**STAFF REPORT**  
**KETCHUM PLANNING AND ZONING COMMISSION**  
**MEETING OF DECEMBER 9, 2025**

**PROJECT:** Warm Springs Townhomes

**FILE NUMBER:** P24-063

**APPLICATION:** Design Review

Figure 1: Subject Property

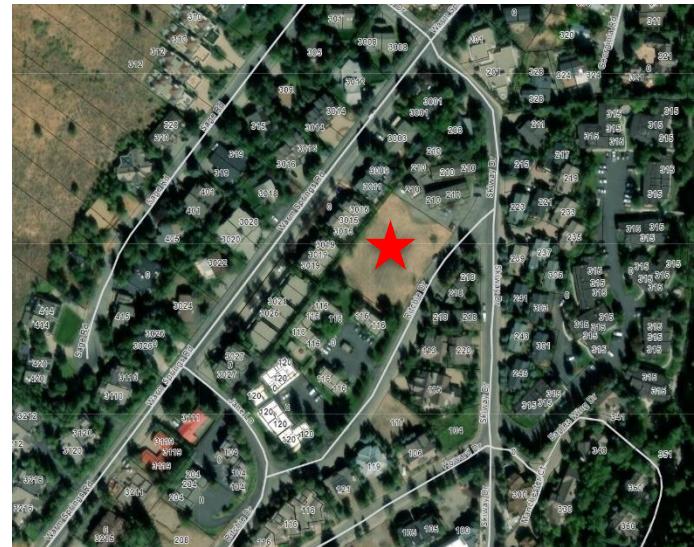
The applicant has submitted a Design Review application for the development of 12-, three- and four-bedroom, townhouse units at 108 Ritchie Dr (the “subject property”). The subject property is zoned Tourist 3000 (T-3000) and is vacant (See Figure 1). The development proposes to utilize the city’s density bonus program for increased FAR and is therefore subject to the minimum residential density requirements of the Ketchum Municipal Code. The townhouse units range in size from approximately 2,200 to 3,800 gross square feet. The units within the development are proposed to be accessed by a private road entering from Ritchie Dr. Each townhouse has dedicated garage parking within each unit. The full project plans are included as Attachment A.

DRAWING TITLE:  
**BUILDING ELEVATIONS -  
BUILDING 1 & 2**

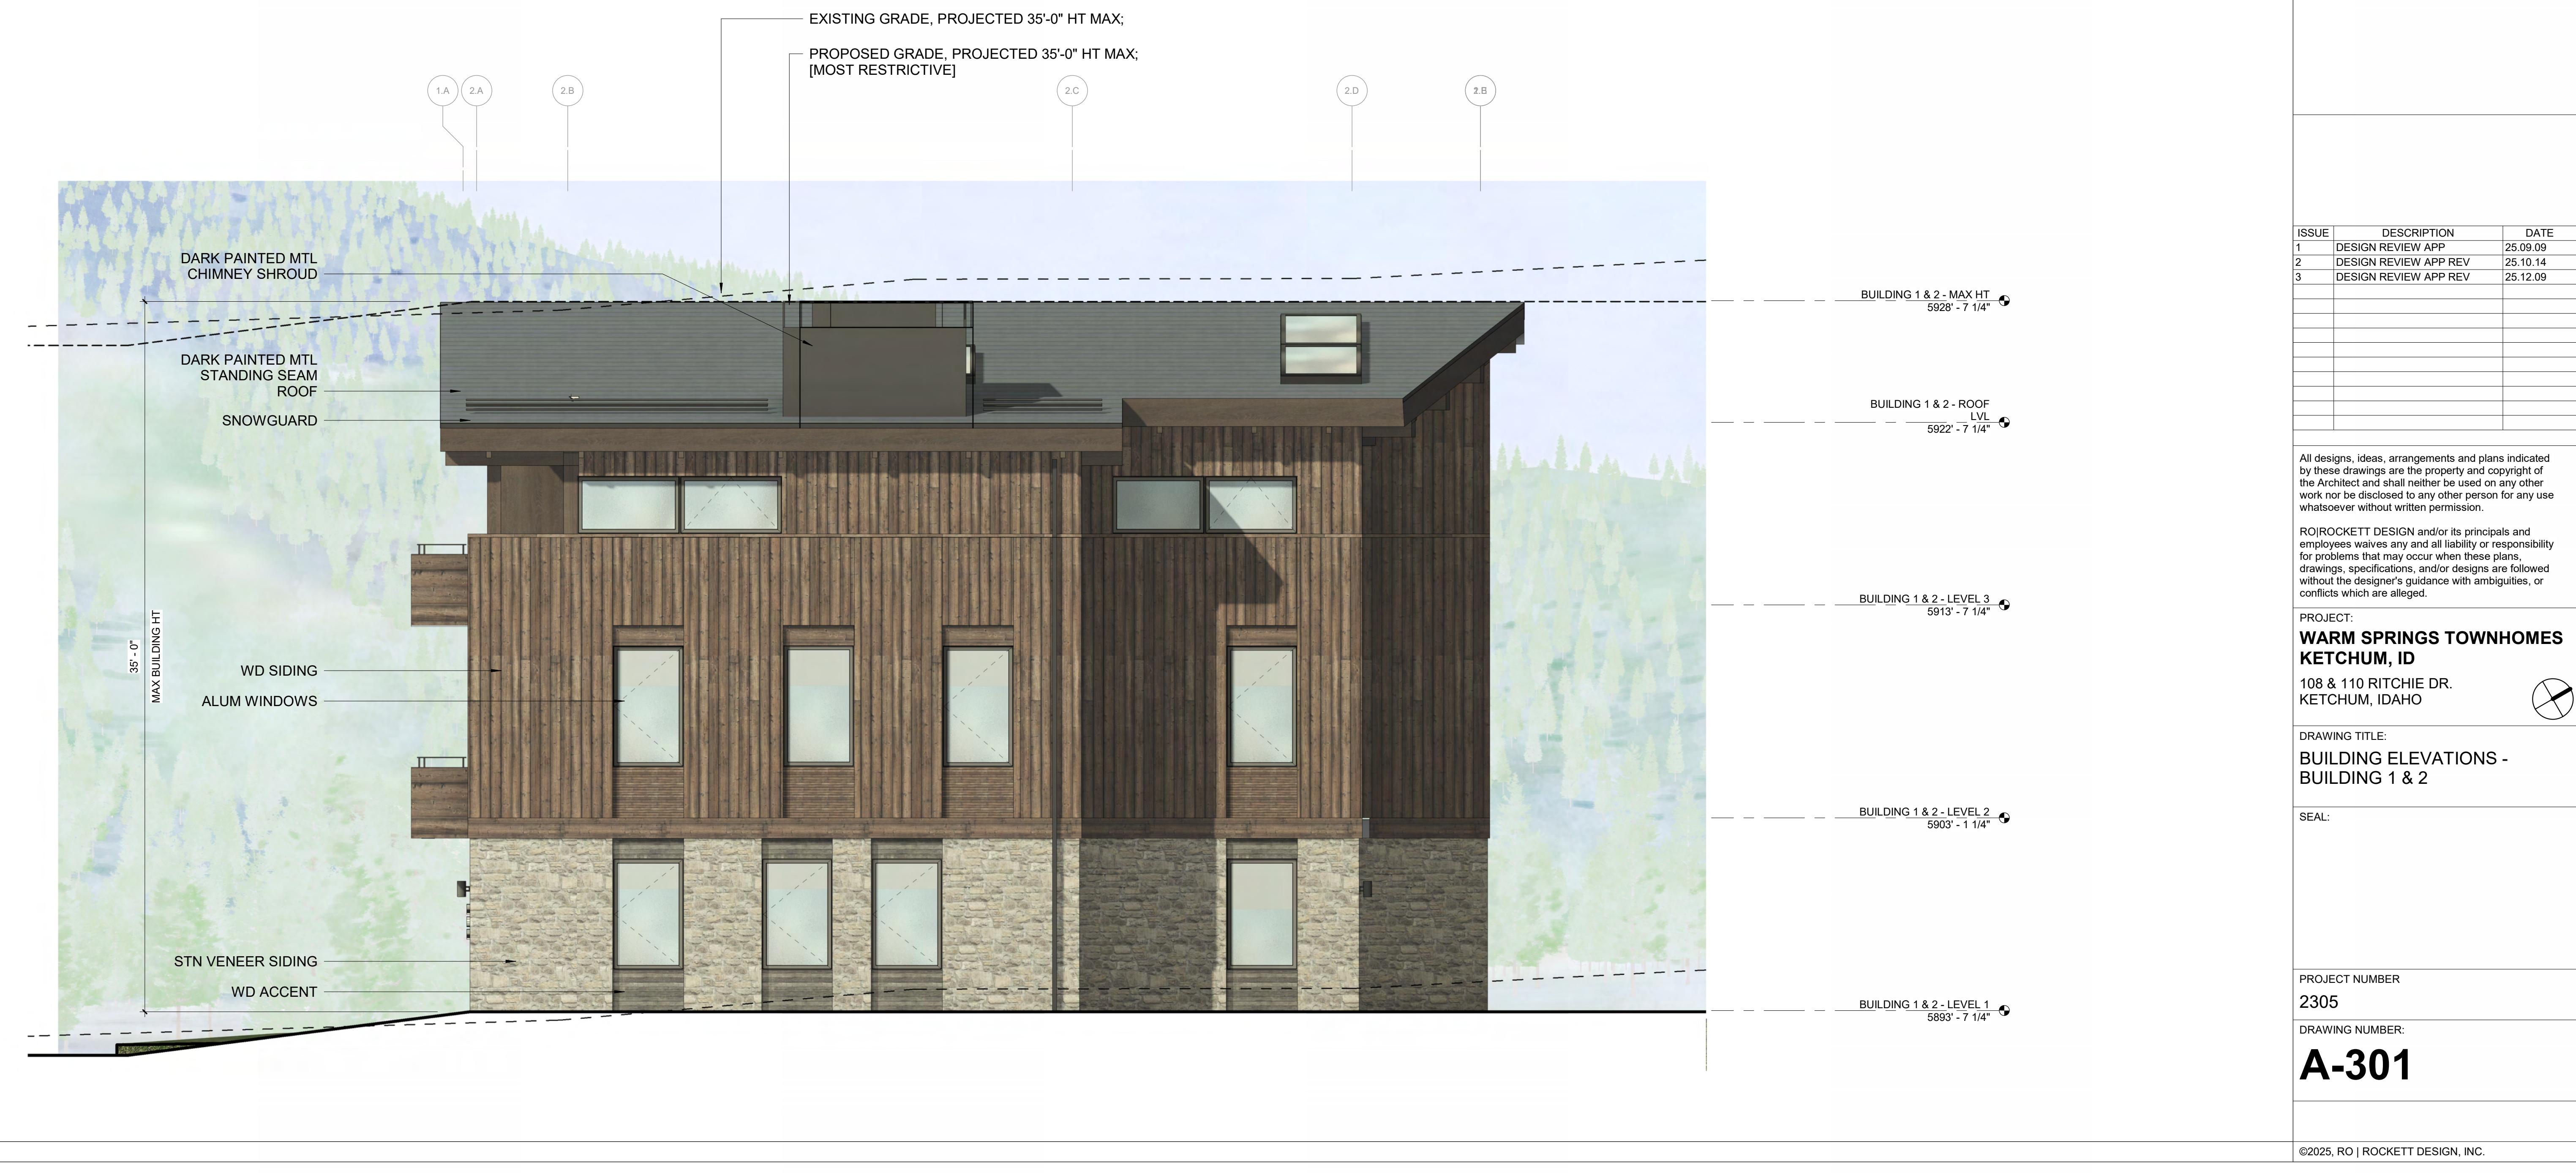
At the previous Commission hearing on October 14, 2025, staff understood the Commission's main concern was the project's compliance with design review standard 17.96.060.F.5 "Building walls shall provide undulation/relief, thus reducing the appearance of bulk and flatness". As noted above, the Commission requested the applicant further evaluate was to reduce the appearance of bulk and flatness of the project, specifically buildings 1 and 3. One suggestion made by the Commission was to evaluate breaking Buildings 1 and 3 into two structures. The applicant has complied with the Commission's request and separated Buildings 1 and 3 into two structures each with just over 10 feet of separation between the buildings. Figure 4 is a rendering of the previous proposal for Building 1 and Figure 5 is a rendering of the current proposal.

Staff believe that separation of the building adds a dimension to the project by providing a view corridor between buildings to the rest of the development and adequately breaks the façade. The building code requires a minimum five-foot separation between structures. Staff is very supportive of the proposed 10+ foot separation of structures as it allows for a clear and distinct separation, shadow casting on adjacent structures, and a clear break in the roof lines. As shown in the additional renderings in the project plans, the building separation also creates the appearance that the buildings are staggered when viewed from certain angles as shown in Figures 6 and 7 below.

The applicant has since further revised the project to address the comments by the Commission by breaking Buildings 1 and 3 into two separate structures. The initial proposal included four buildings, two with four units each and two with two units each. The current proposal includes a total of six buildings, each with two units. The proposed change results in the following:
